# Gosford Alive

## Concept DA & Stage 1 works

Response to Submissions

Mecone Pty Ltd on behalf of Lederer Group  
April 2020

**Figure 4** Amended setbacks  
Source: Buchan

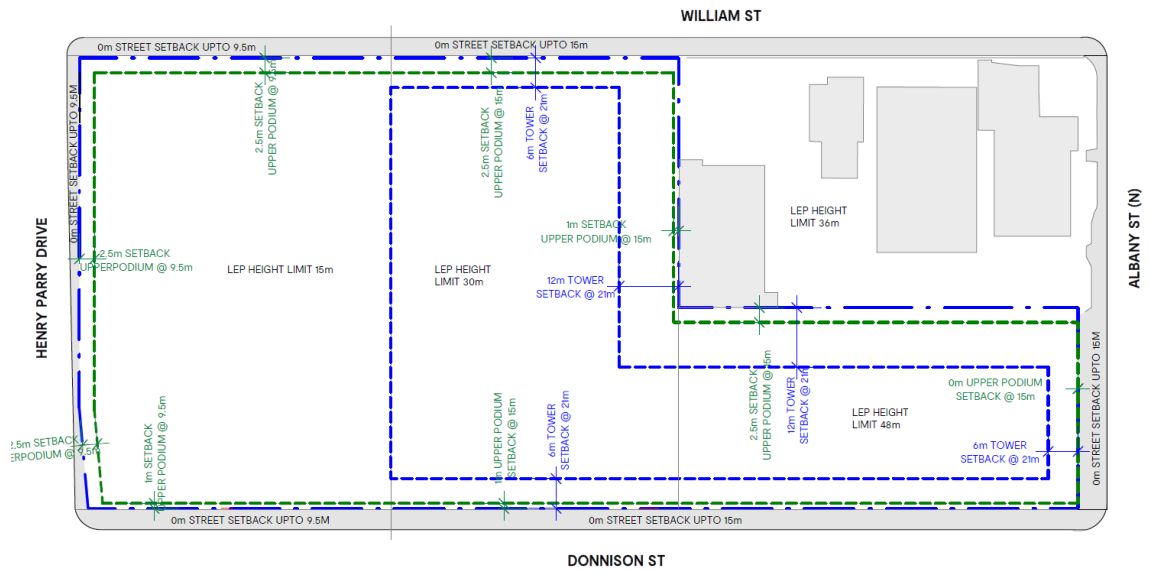
A common theme raised by DAP and DPIE related primarily to the bulk and scale of the built form (heights of buildings and podiums, setbacks) and general massing, modulation and articulation of the building envelopes. As well as this, concerns were raised regarding the provision of fine grain frontages and street activation, particularly along the eastern edge.

Issue	Response
<p>Noting the advice from the Panel and issues raised in submissions, the Department also requests that the overall height, bulk and scale of the proposal be reviewed, and consideration given to:</p> <ul style="list-style-type: none"> <li>reducing the height and bulk of the Tower 1 envelope and improving the setback to reduce its visual dominance and enhance solar access to Kibble Park</li> <li>reducing the height and bulk of the Tower 5 envelope to create a scale transition between Tower 4 that integrates with the existing and future built form character on Albany Street and the lower portions of Rumbalara Reserve</li> <li>reducing the podium heights to reduce the visual dominance of the proposal and ensure street walls create an appropriate human scale</li> <li>providing additional vertical articulation in all the buildings, to reduce the perceived bulk and scale of the buildings when viewed from key vantage points (this may be specified in the design guidelines above)</li> <li>refining tower setbacks, siting, separation and floorplate sizes across the site to improve future (residential and environmental) amenity and reduce visual impacts.</li> </ul>	<p>The proposed built form has been reviewed, as requested, and subsequently amended reflecting a significantly reduced bulk and scale. The change in building heights are as follows:</p> <ul style="list-style-type: none"> <li>Tower 1 has been reduced from RL89 to RL82.4;</li> <li>Tower 3 has been reduced from RL92 to RL88.6; and</li> <li>Tower 5 has been reduced from RL 110 to RL 101.</li> </ul> <p>Significant changes to Tower 5 have taken place from reducing the overall height, implementing a 'step' in the height, and redistributing massing to lower the tower form by increasing the podium heights, all of which will better interact with current and potential future developments at this frontage.</p> <p>An improved relationship to Kibble Park has been created through slightly reduced podium heights along Henry Parry Drive and the reduced Tower 1 envelope.</p>

In addressing these concerns among others, envelopes have been tightened and reduced to minimise perceived bulk and scale, particularly from public domain areas, including Kibble Park. In addition to this, the heights of Towers 1 and 5 have been reduced with the envelope of Tower 5 stepped down towards Albany Street. Podium envelope height has slightly increased on Albany Street to better respond to the existing built form on the opposite side of the subject site. These built form changes have resulted in a reduction to apartment numbers and total gross floor area, as described in the table on the following page. All street frontages have been amended to provide for improved activation with the public domain.

1. Tower envelopes improved as follows:
  - a. Envelopes tightened and reduced, to minimise perceived bulk & scale, especially from Kibble Park.
  - b. Tower 1 envelope reduced in height by 6.6m.

- c. Tower 5 envelope reduced in height by 9m and stepped down towards Albany.
  - d. All envelopes stepped to codify top building form articulation into the envelopes.

**Figure 8** Amended Albany Street North Elevation  
Source: Buchan

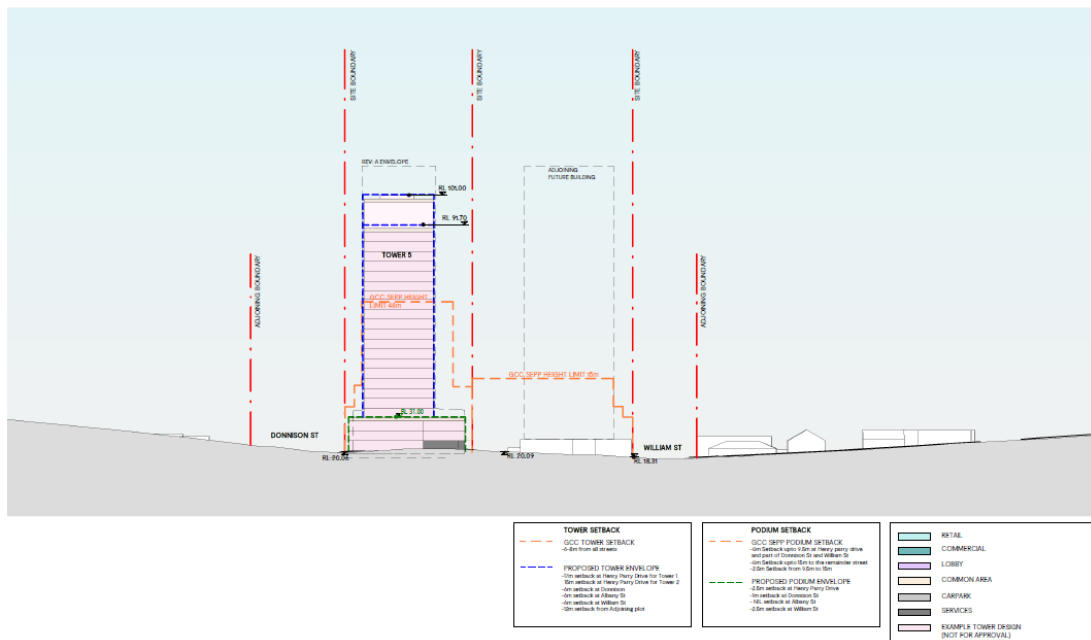
Albany Street and existing development on the eastern side of Albany Street and greater articulation towards the top of the tower should be considered (including stepping down towards Albany Street).	lower within the tower form by increasing the podium heights, all of which will better interact with current and potential future developments at this frontage.
The Panel recommends further refinement of the Donnison Street frontage with consideration given to further residential development, at street level, whilst appropriately screening car parking. Consideration could be given to a skin of residential development along the Donnison Street frontage.	The suggestions of the CoDAP have been implemented. Car parking along Donnison Street has been screened with residential development.

- e. Towers 1 & 5 articulation adjusted to present more vertical proportion.
2. Podium envelope height increased on Albany Street to better respond to Albany Street existing built form and street frontage heights.
